**ADDENDUM NUMBER: ONE**

**PROJECT:** Pamlico County EOC / 911 Dispatch  
Bayboro, North Carolina  
Project Number 18068

**DATE:** October 9, 2024

Date	Project No.
09.12.24	<b>24017</b>
Drawn By	Sheet No.
MCB	<b>E1.2</b>
Checked By	
MCB	
Sheet Title	
POWER PLAN

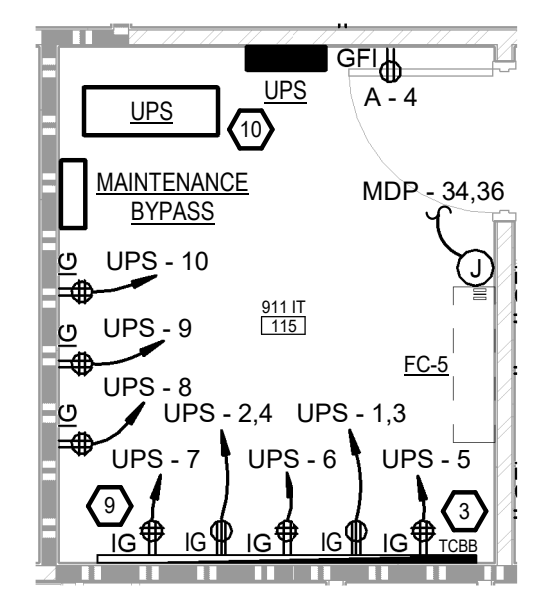
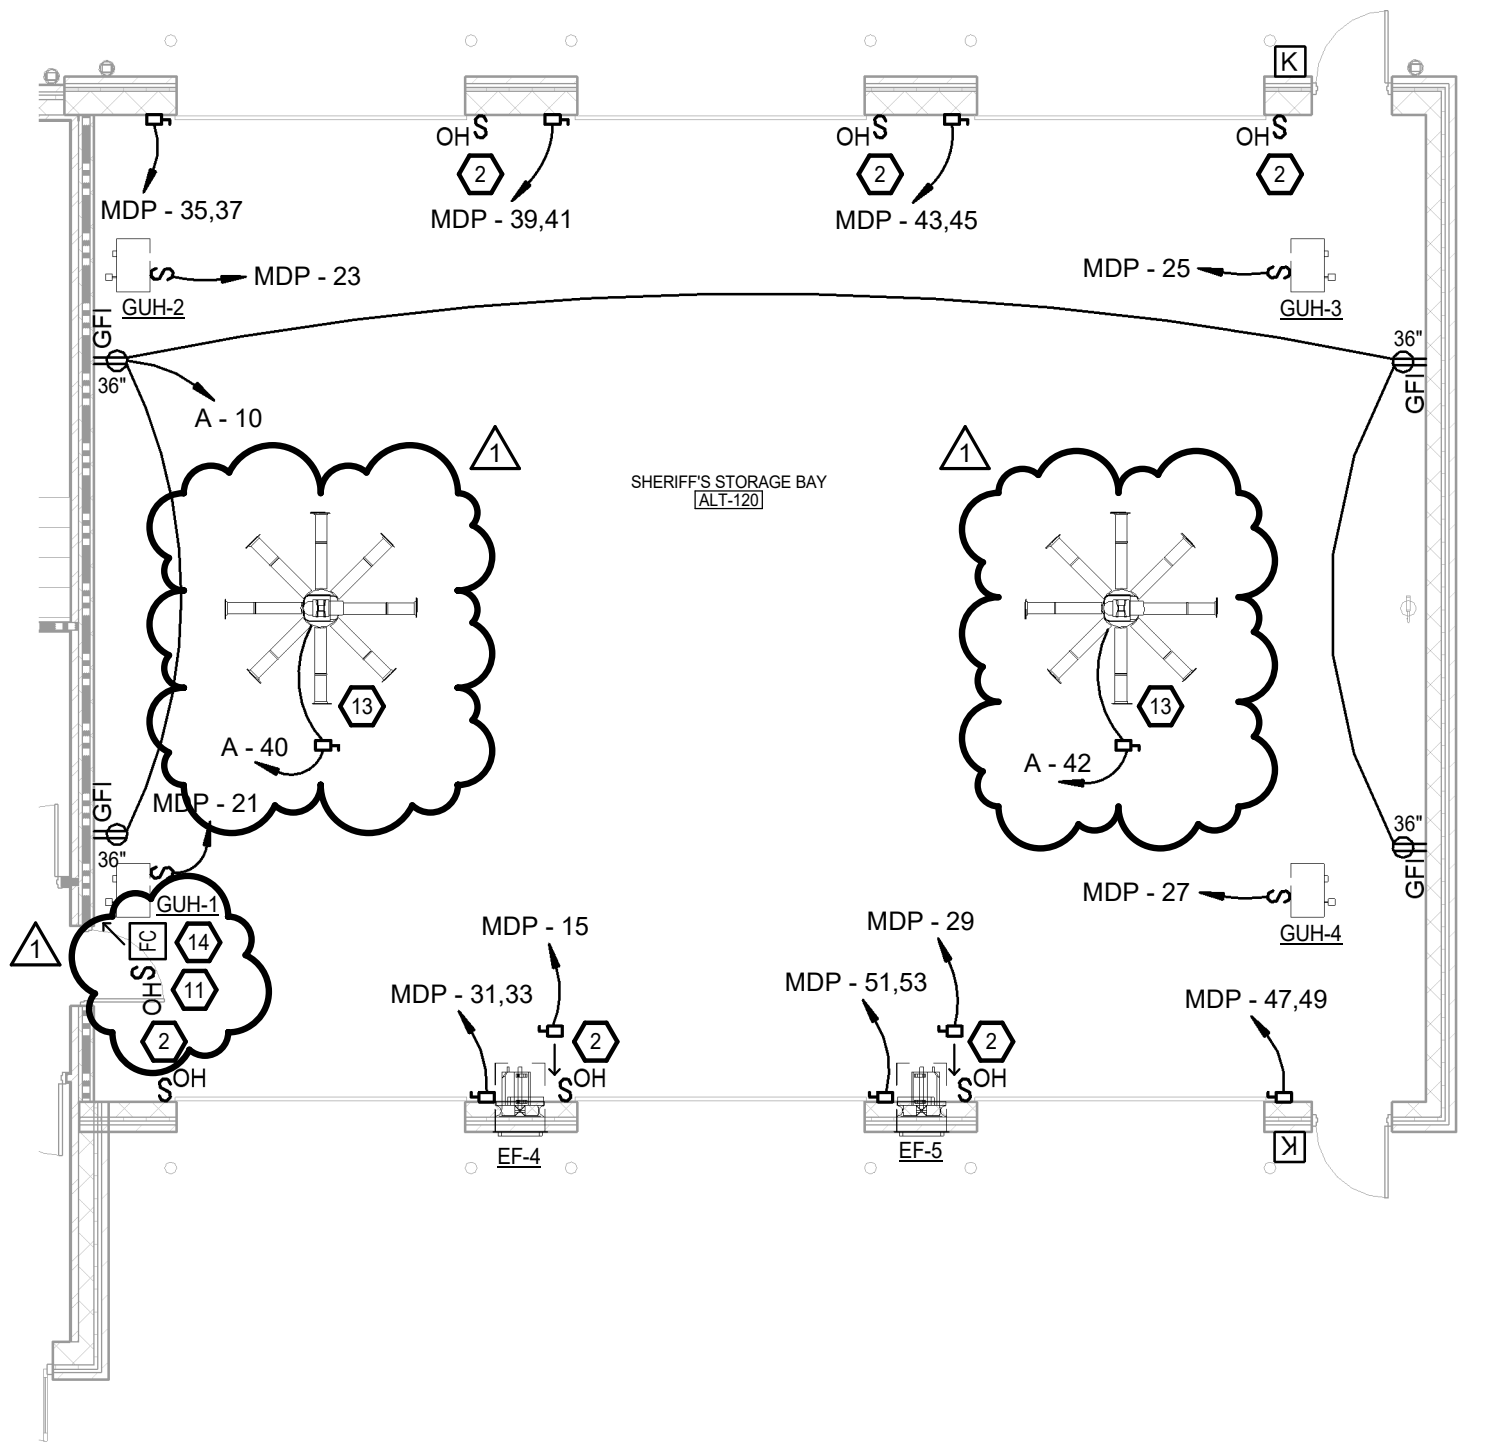
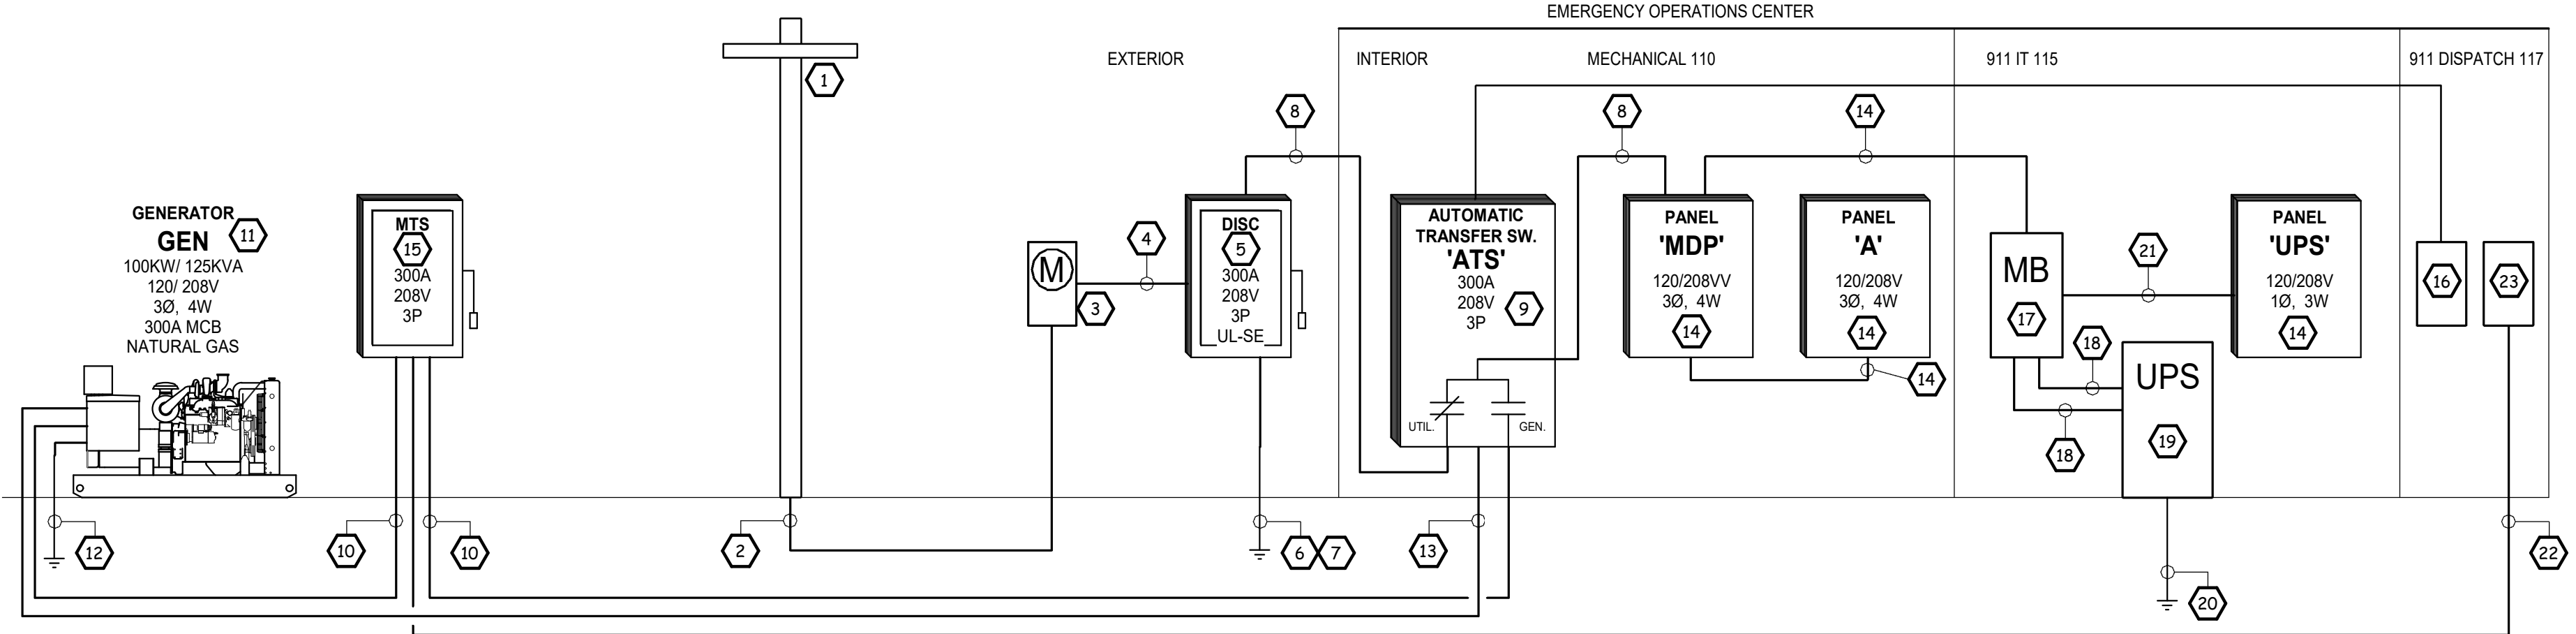
**Item 4 Change:**     **Sheets E1.2 – Power Plan & Sheet E2.1 Power Riser, Panel Schedules**  
Replace Sheets E1.2 – Power Plan & Sheet E2.1 Power Riser, Panel Schedules in their entirety. Revisions include the addition of High-Volume Low Speed fans to the Sheriff’s Storage Bay in both the Base Bid and the Alternate G-1 Bid plans, changes resulting from coordination with Duke Energy, and the removal of the requirement for a load bank connection on the MTS. All changes have been clouded.
